PLANNING BOARD STUDY SESSION AND MEETING AGENDA

AGENDA TITLE: Public hearing to consider **Concept Plan**, no. LUR2013-00049, for the phased subdivision and redevelopment of the 45.5-acre Western Disposal Services site at 2655 N. 63rd St. to include sites for light industrial and technology development businesses as well as a potential waste transfer station and public access drop-off facility adjacent to the existing compost facility. The site is zoned IM (Industrial- Manufacturing).

Project Name: Western Industrial Park
Location: 2655 N. 63rd St.
Size of Tract: 45.5 acres
Zoning: IM (Industrial- Manufacturing)
Comprehensive Plan: General Industrial

CITY OF BOULDER
LAND USE REVIEW RESULTS AND COMMENTS

1 CONCEPTUAL SITE PLAN
1" = 100'-0"

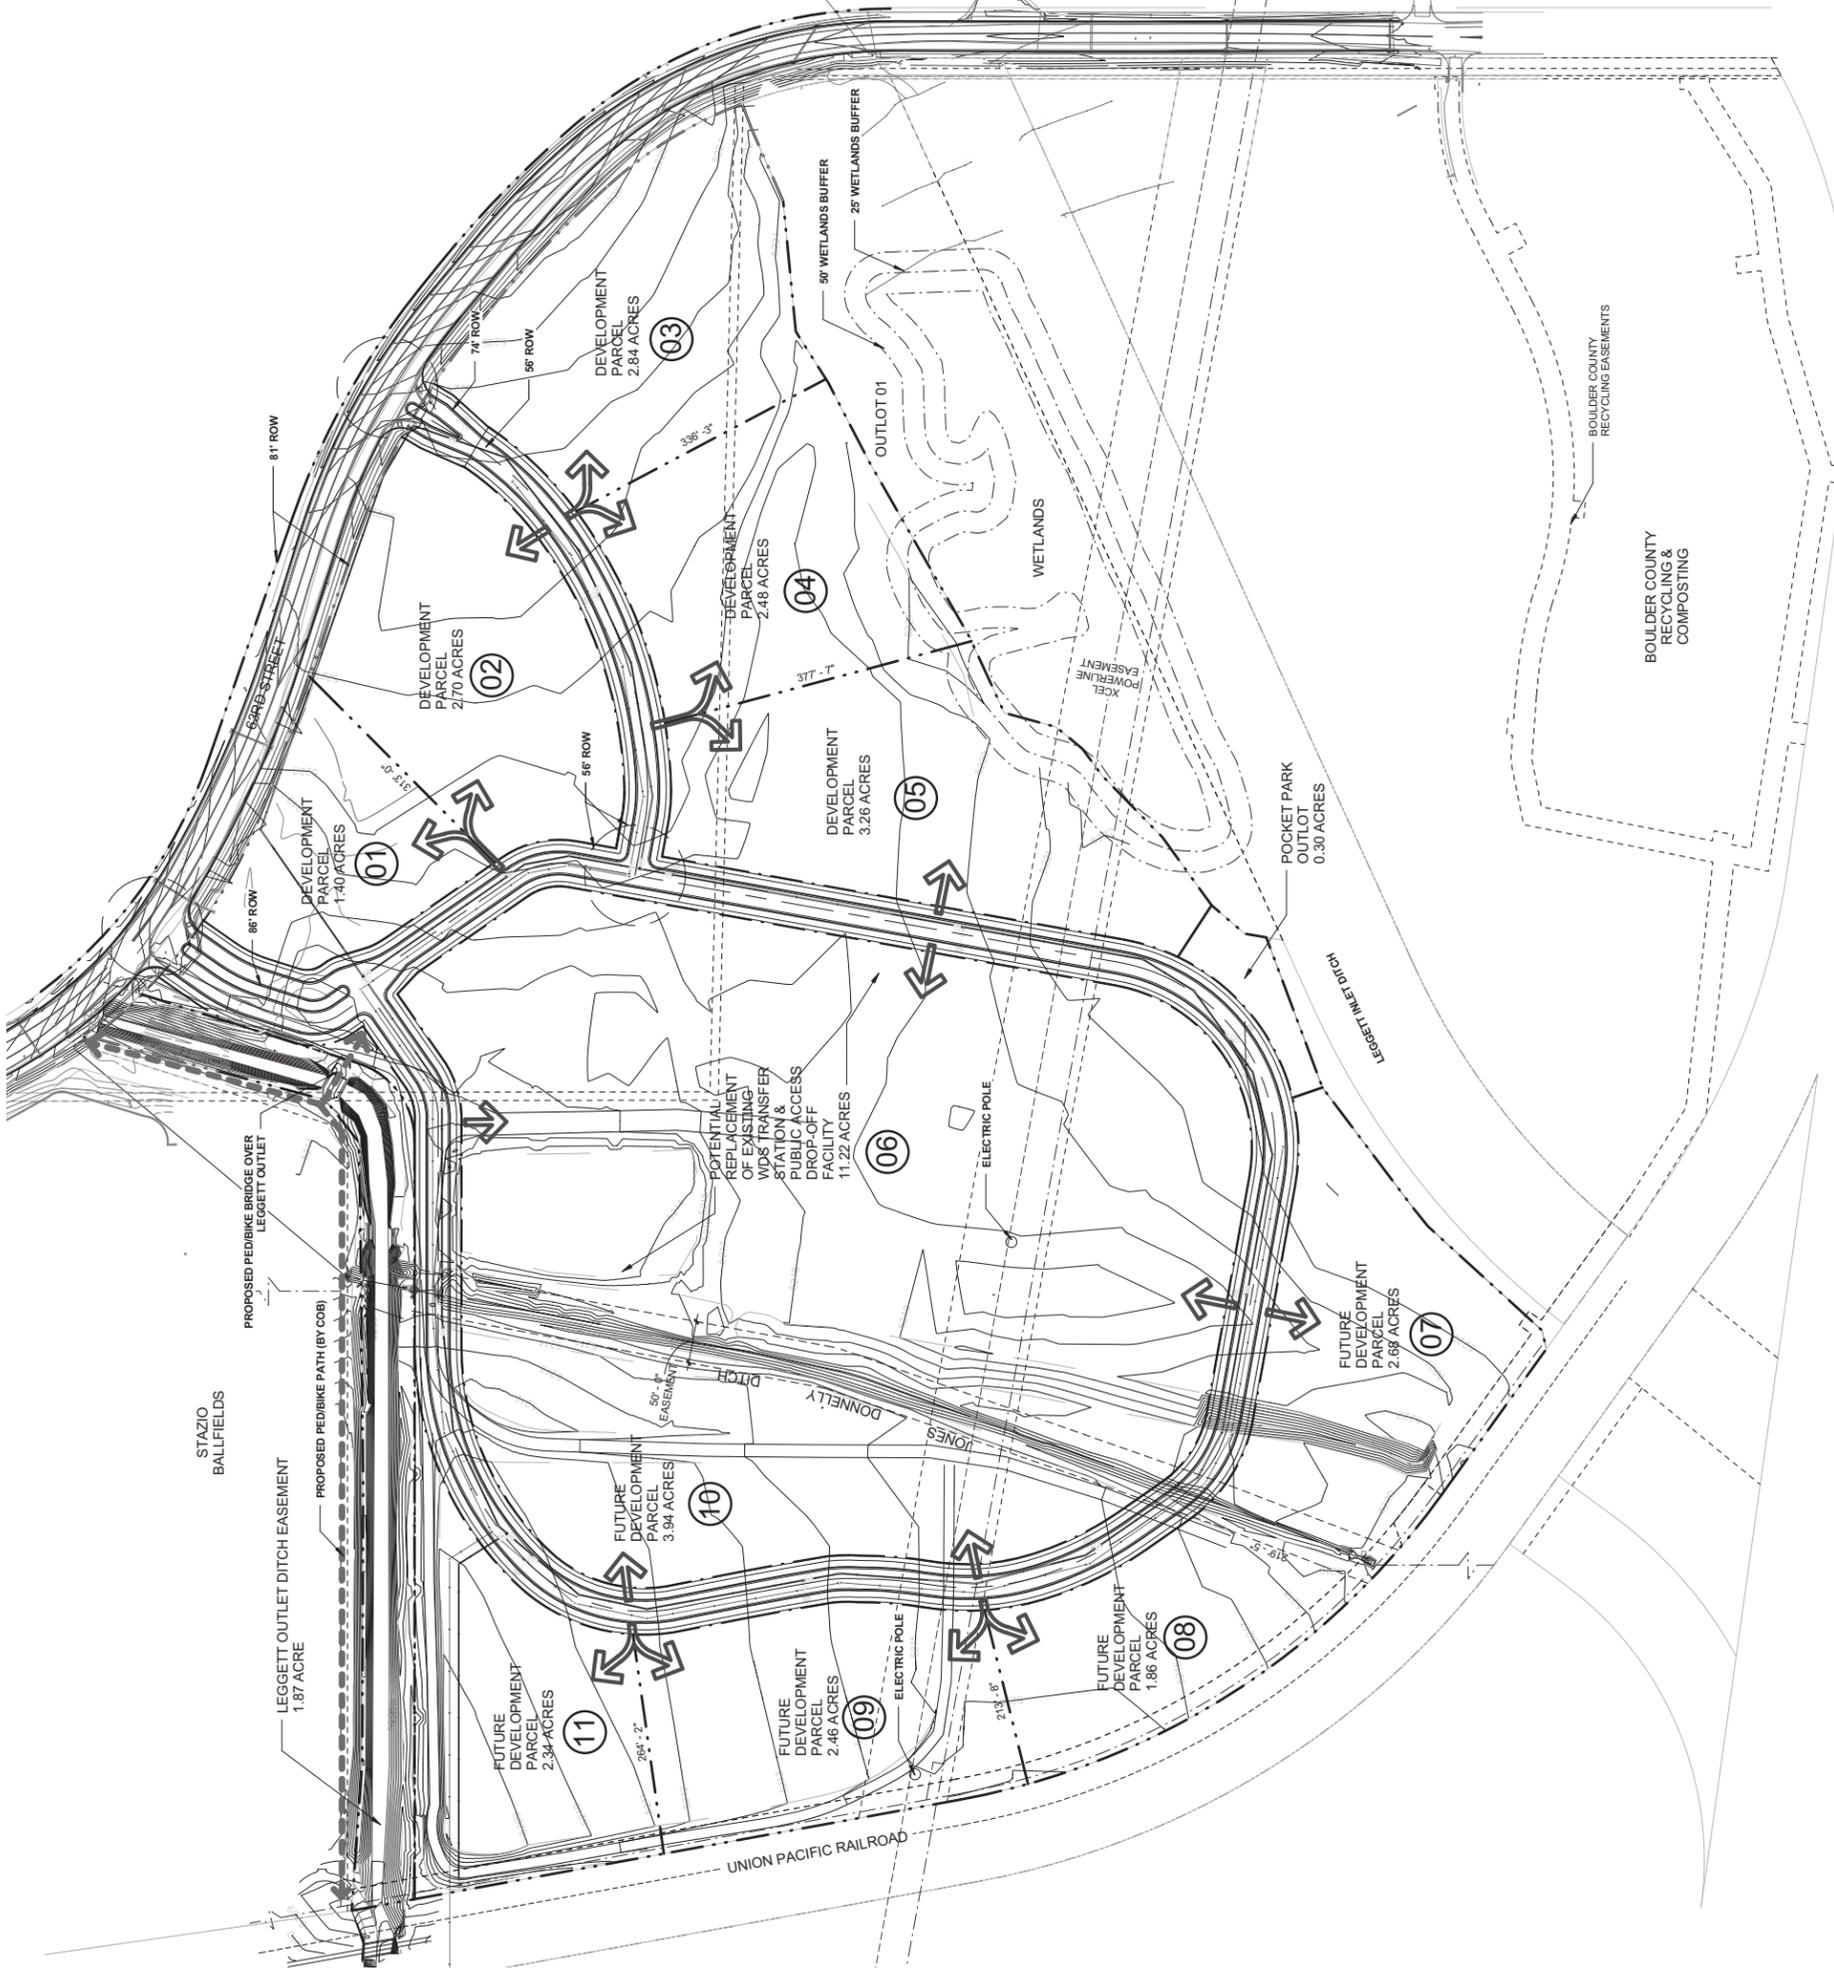
1. The geometric design of the internal streets must meet the minimum standards outlined for a local road in Section 2.07 of the City of Boulder Design and Construction Standards (DCS).
2. The internal streets must provide a minimum paved street section width of 36-feet (curb face to curb face) as shown in Table 2-3 of the DCS. Please note the right-of-way width will need to be increased in order to accommodate the minimum paved street section.
3. At time of site plan submittal, a traffic study and transportation demand management (TDM) plan must be completed for the build-out of the site. Staff is available to meet with the applicant to discuss the parameters of the traffic study and TDM Plan.
4. At time of site plan submittal and pursuant to Section 9-9-7 of the Boulder Revised Code (BRC) sight triangles must be shown at street intersections.

5. At time of site plan submittal and per Section 2.10(D)(4) of the DCS, the site submittal must show that the north and south entrances from North 63rd Street and the street intersection within the site can accommodate the minimum turning radius of an SU-30 emergency vehicle.
6. Pursuant to Section 9-9-5(c)(1) of the BRC, only one access point per lot is permitted unless a traffic study demonstrates that additional access points and curb cuts are required to adequately address accessibility, circulation and driveway volumes. Additional accesses and curb cuts must be shown to not impair any public use of any right-of-way or create safety or operational problems or be detrimental to traffic flow on adjacent public streets.

Fire has no issues with concept plan. All buildings that will be built on the site will be required to have a fire sprinkler system installed, system monitored and interior notification. Access in and around the site appears to be acceptable however, more detailed review will be on the site plans.

1. Section 9-2-14(h)(2)(E)(iii) of the Site Review criteria requires that "*Parking areas and lighting are designed to reduce the visual impact on the project, adjacent properties, and adjacent streets;*" however, Section 2.4(A) of the Concept Review Design Guidelines shows parking setbacks as being less than building setbacks in nearly every instance. While it may be supportable to allow for parking area setbacks to be less than building setbacks for side and rear yards in certain contexts, staff recommends that the front yard setbacks for parking areas be at least the same distance as buildings in order to ensure a building-forward design.

1. Per Section 5.10 of the City of Boulder *Design and Construction Standards (DCS)* all distribution mains shall be looped into the existing water system to ensure at least two feed sources and to maintain system strength. Only one connection to the existing system is shown on the plans.
2. Water main extensions for additional fire hydrants within the individual lots may be necessary to meet the coverage requirements in Section 5.10 of the *DCS*. Per the standards, no portion of any building shall be over 175 feet of fire access distance from the nearest hydrant.
